1. Type of Well						
✔ Oil Well	Gas W				8. Well Name and No	^{).} STREETCAR 15 FED 206H
2. Name of Operator EOC	G RESOUR	CES INCORPORATED			9. API Well No. 30-0	25-47507
3a. Address 1111 BAGE	Y SKY LOB	BY 2, HOUSTON, TX 77(3b. Phone 1 (713) 651-	No. <i>(inclı</i> -7000	ıde area code)	10. Field and Pool or DRAPER MILL; B

Update casing and cement program to current design.

Revised Permit Information 09/28/2023:

Well Name: Streetcar 15 Fed 301H

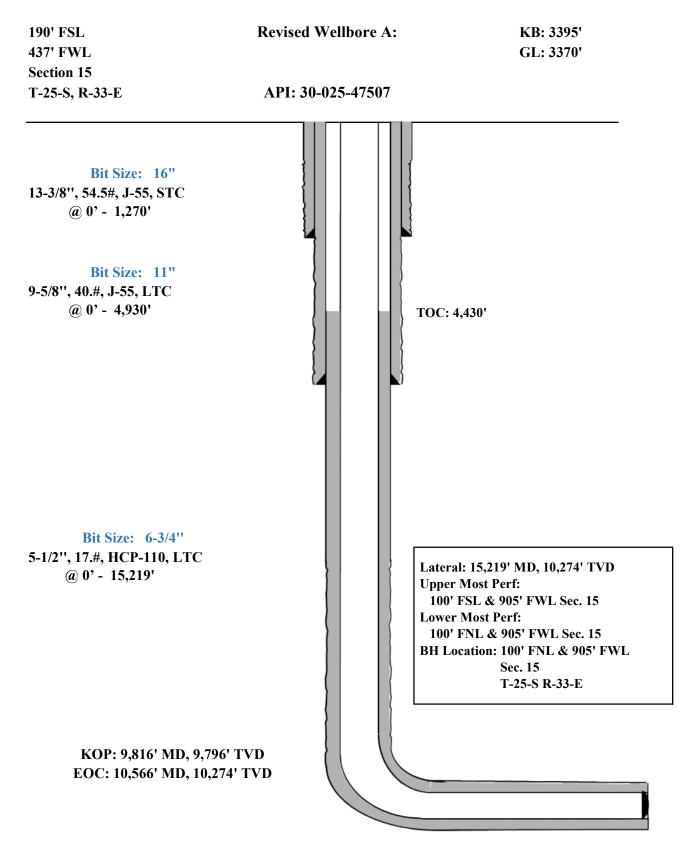
Casing Program B:

Hole	Interv	Interval MD Interval TVD		Csg				
Size	From (ft)	To (ft)	From (ft)	To (ft)	OD	Weight	Grade	Conn
13-1/2"	0	1,270	0	1,270	10-3/4"	40.5#	J-55	STC
9-7/8"	0	4,020	0	4,000	8-5/8"	32#	J-55	BTC-SC
9-7/8"	4,020	4,950	4,000	4,930	8-5/8"	32#	P110-EC	BTC-SC
6-3/4"	0	15,219	0	10,274	5-1/2"	17#	HCP-110	LTC

Variance is requested to waive the centralizer requirements for the 8-5/8" casing in the 9-7/8" hole size. An expansion additive will be utilized, in the cement slurry, for the entire length of the 9-7/8" hole interval to maximize cement bond and zonal isolation.
